CITY PLAN COMMISSION

FILE NUMBER: S234-049

REQUEST: An application to create one 0.2755-acre lot from a tract of land in City Block 6548 on property located on Reeder Road, north of Royal Lane.

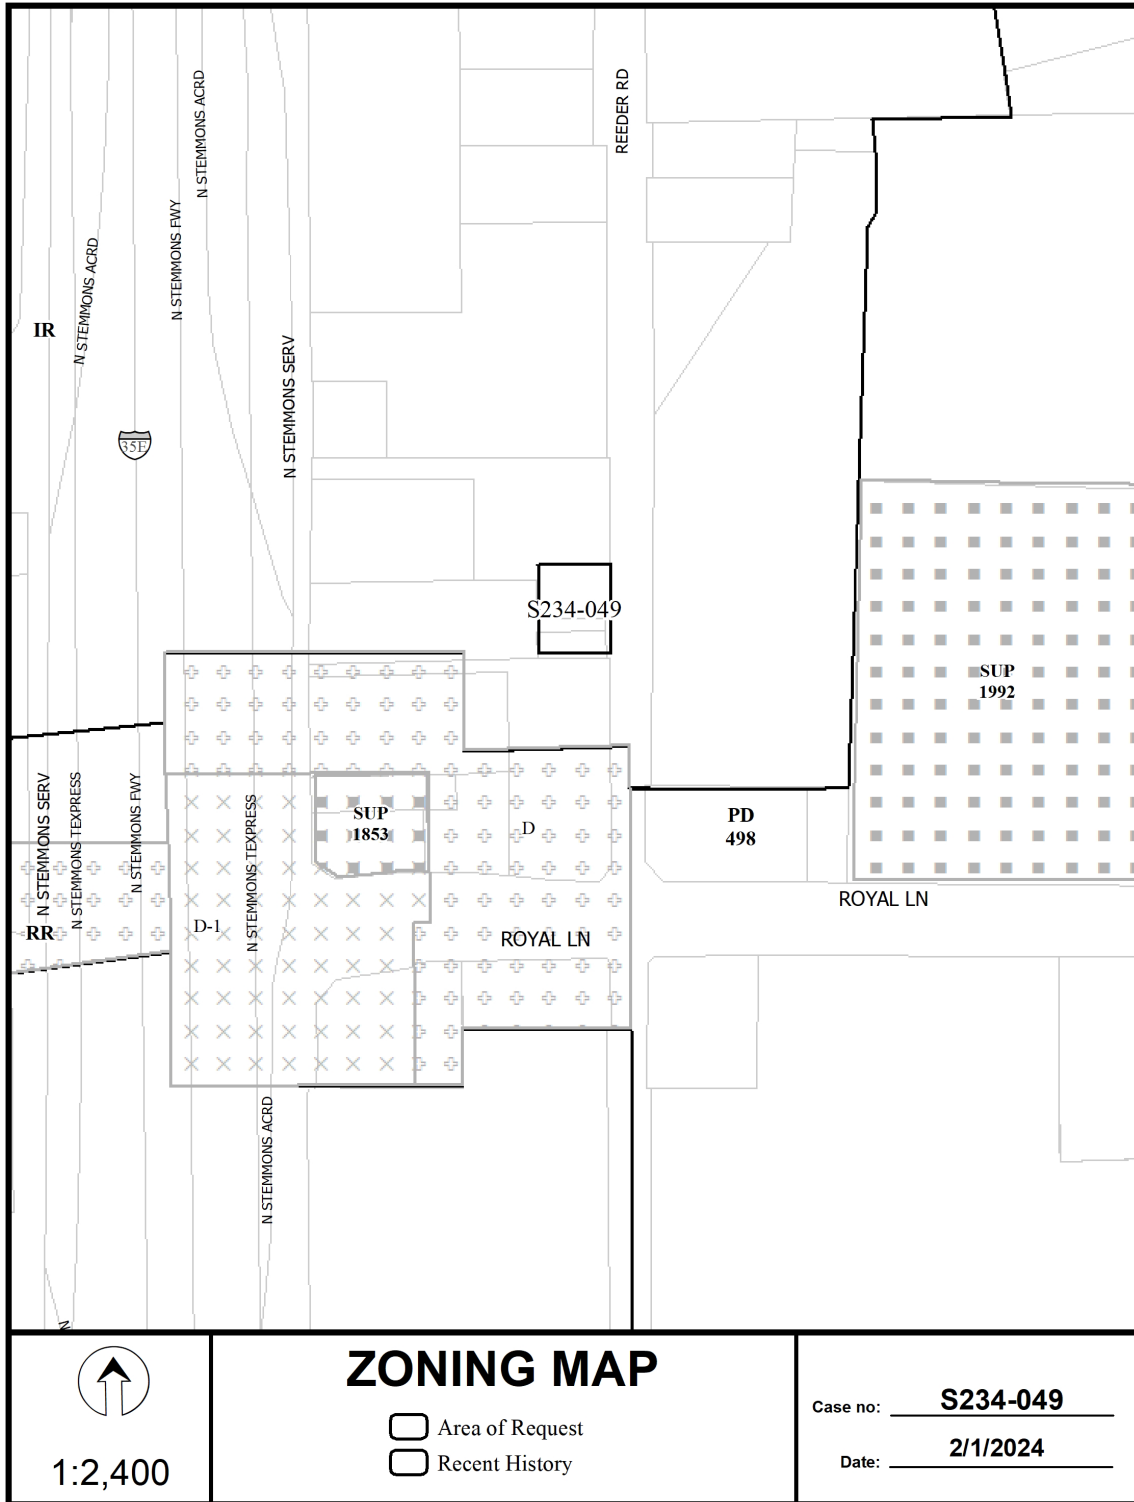
22. Additional design information is required for assessment. Site plan must be submitted showing proposed development, building finished floor elevation, development, existing mains – including downstream manhole, and proposed water and wastewater service locations. Submit water/wastewater engineering

23. Engineer must furnish plans for water and sanitary sewer. Developer must furnish a contract for water and sanitary sewer. Sections 49-60(g)(1) and (2) and 49-62(b), (c), and (f).
24. Water main improvements is required by Private Development Contract. Submit water/wastewater Engineering Plans to 320 E. Jefferson Blvd., Room 200, Attention: Water and Wastewater Engineering.

25. Prior to the final plat, remove fence shown on the plat in right-of-way on Reeder Road. Provide pictures or documentation that shows the fence has been removed from Reeder Road.
26. On the final plat, change “Sprowles Street” to “Stemmons Freeway/ Interstate Highway No. 35E”.
27. On the final plat, identify the property as Lot 1 in City Block C/6548.
